CALVERTON

ADMINISTRATIVE SUBDIVISION PLAN NO. 620230140

FOREST CONSERVATION PLAN NO. F20240010

Administrative Subdivision Plan and Forest Conservation Plan, to create a three-lot subdivision to allow three single-family detached dwellings units.

Figure 4 - Proposed Administrative Subdivision Plan No. 620230040

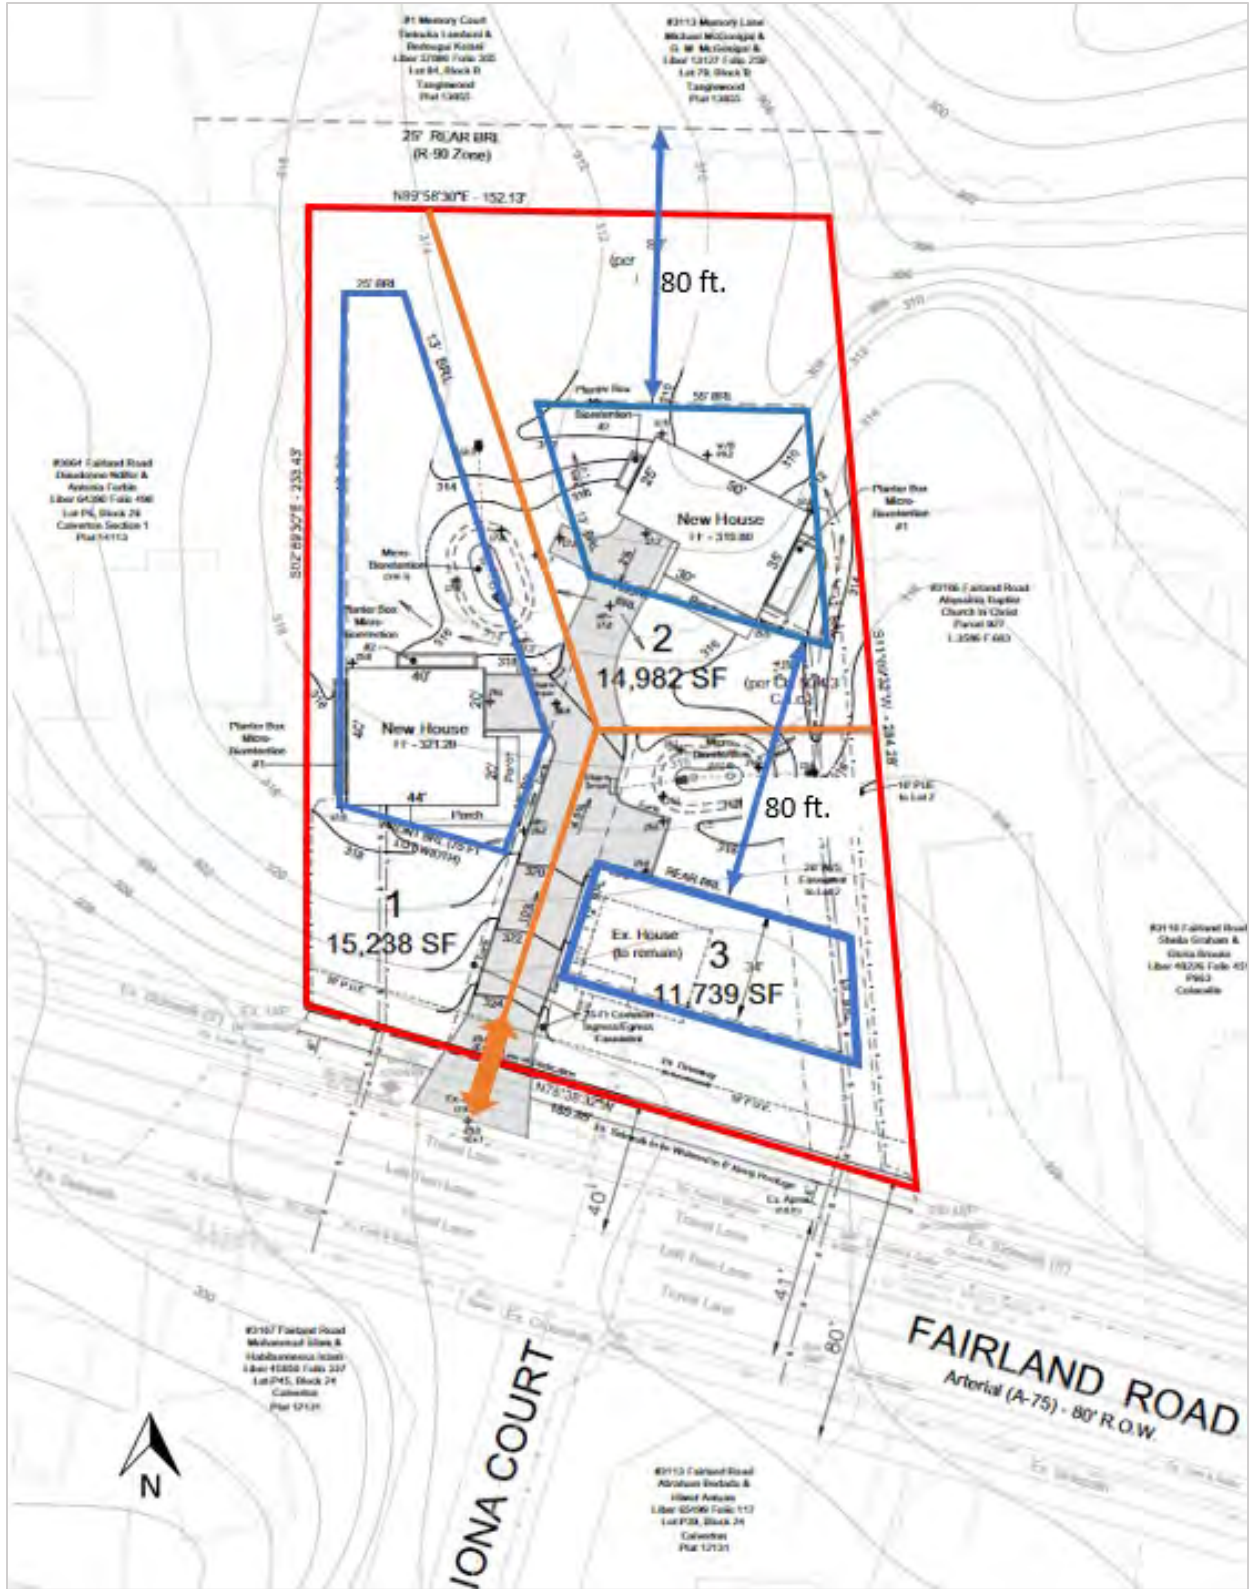
- iii. ***In residential zones, the Board must require building restriction lines as needed to provide separation of at least 80 feet between the building envelope of the proposed lot without frontage and:***

As shown in Figure 4, the Project provides at least 80 feet of separation between the building envelope of Lot No. 2 and the adjacent rear lot line building envelopes of 1 Memory Court and 3113 Memory Lane. Additionally, the Project provides at least 80 feet separation between the building envelope of Lot No. 2 (the lot without frontage) and the building envelope of Lot No. 3 (the lot between the lot without frontage and the road).

Figure 5 – Directional flow of stormwater and elevations noted

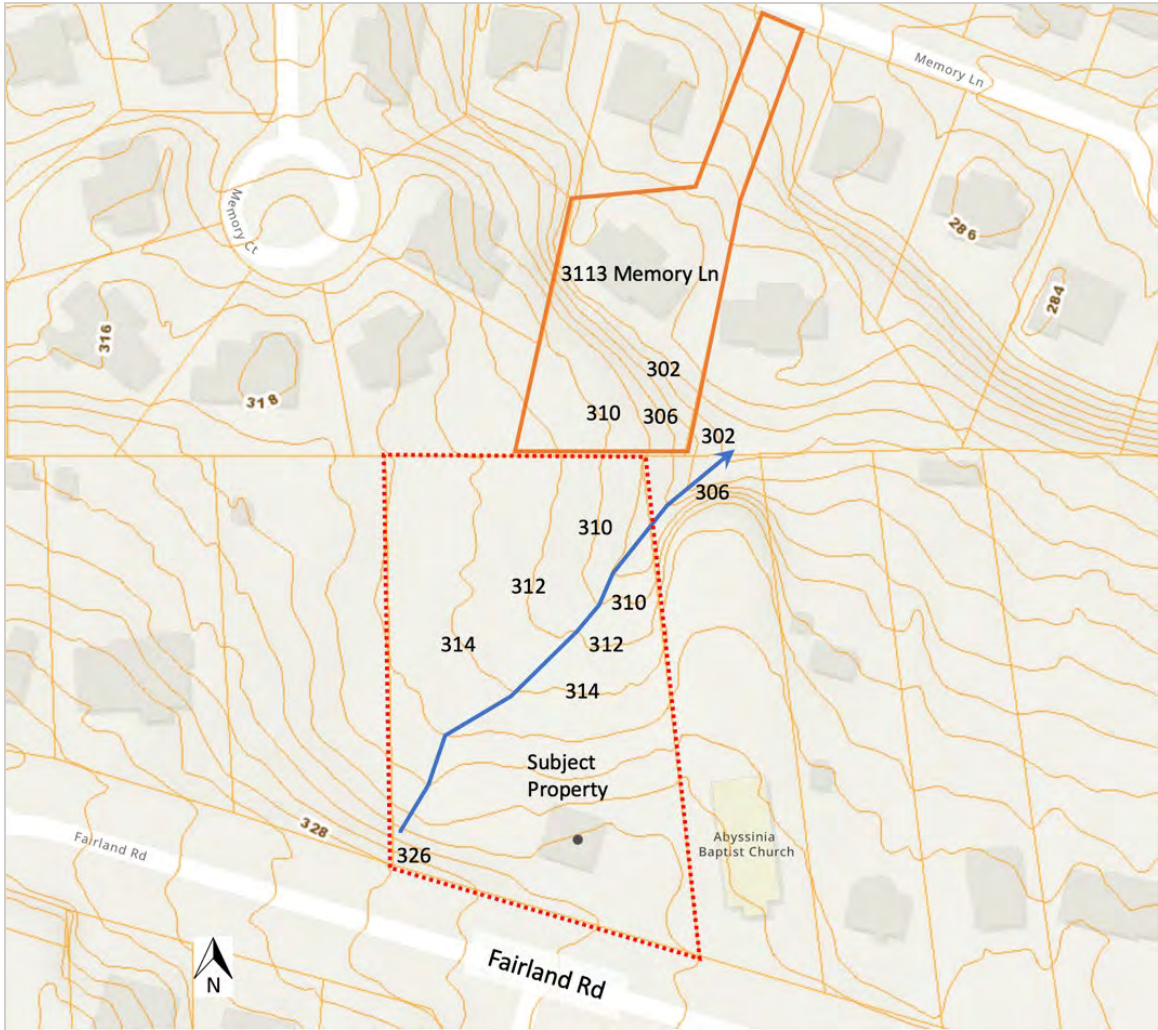
Staff received one letter from an adjacent property owner to the north at 3113 Memory Lane (Attachment E). The property owner expressed opposition to the Project over concerns about off-site flooding impacts to their property.

Figure 5 (below) shows the topography of the Property and immediate vicinity. Topographical contours form a swale from the southwest to northeast direction, as indicated by the blue line below. Spot elevation labels show that the Property slopes downward in the same direction from approximately 328-foot to 306-foot contour elevation. The Property does not slope downward toward 3113 Memory Lane, it slopes upward. As such, there would be no drainage impact to 3113 Memory Lane because stormwater runoff will not flow upward to higher elevations. Additionally, the Application has an approved Stormwater Management/Site Development Stormwater Management Plan, which manages stormwater runoff from the proposed development. Stormwater will be managed with two (2) bioretention facilities and four (4) micro bioretention planter boxes.
